TURBO OUTFUN U/R CVT

NEW PARTS AND REPLACEMENT PARTS

TURBO OUT RUN (834-6919-12)

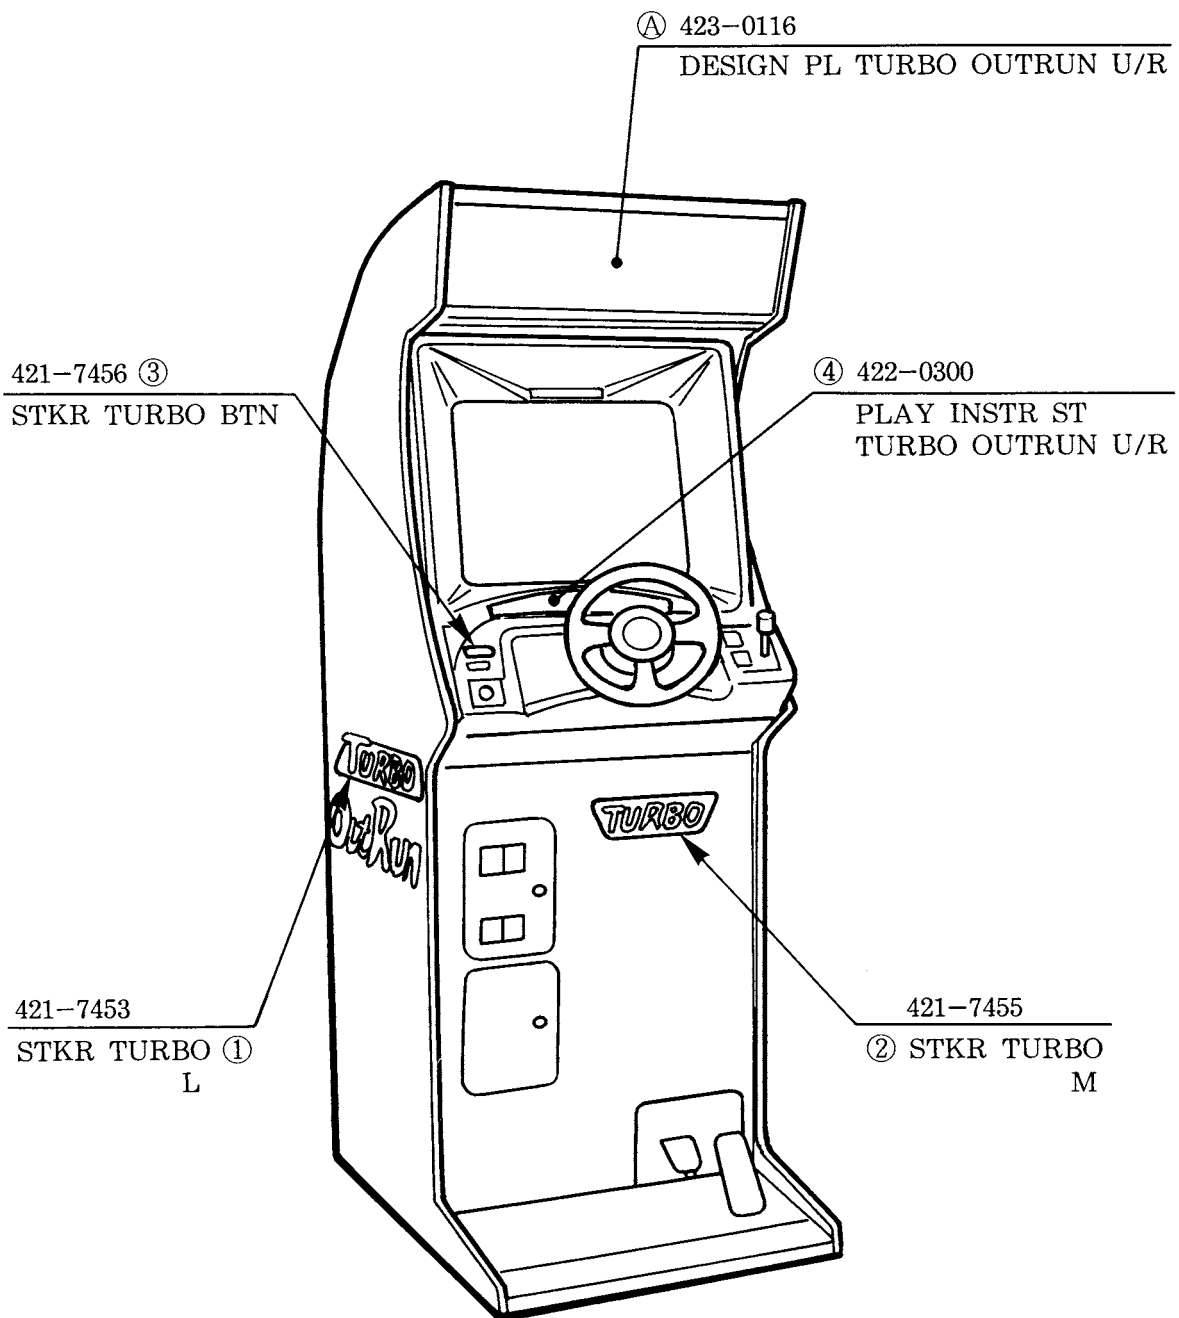
1. Apply STICKER ① (one each on the right and left sides), and one each of ②, ③ and ④ to the applicable positions as shown.
2. Then, replace the ⑤ parts.

CPU BD 837-6905-12

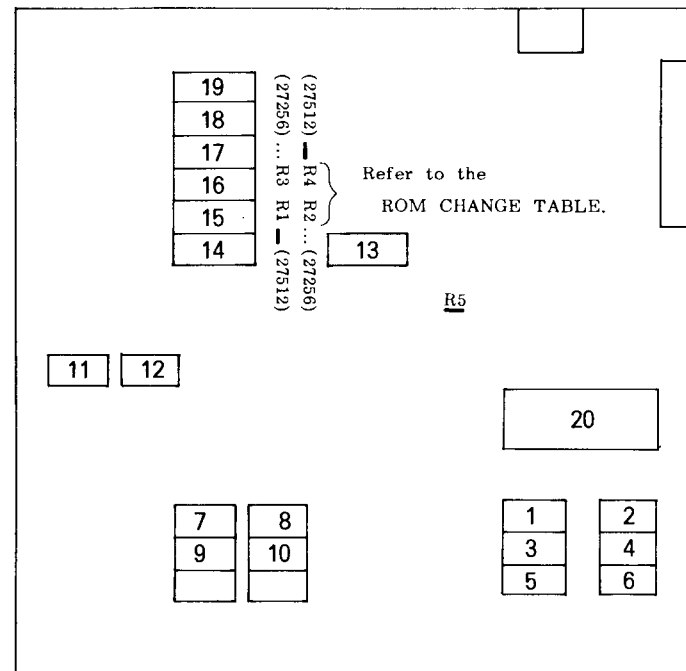
To change to the TURBO OUT RUN from the OUT RUN, the ROM replacement, and the jumper changes as shown below are required.

CPU BD 837-6905-12

CPU BD	R1	R2	R3	R4	R5	ROM TYPE
SOUND PROGRAM	JUMPER	CUT	/	/	JUMPER	27512
SOUND DATA	/	/	CUT	JUMPER	JUMPER	27512
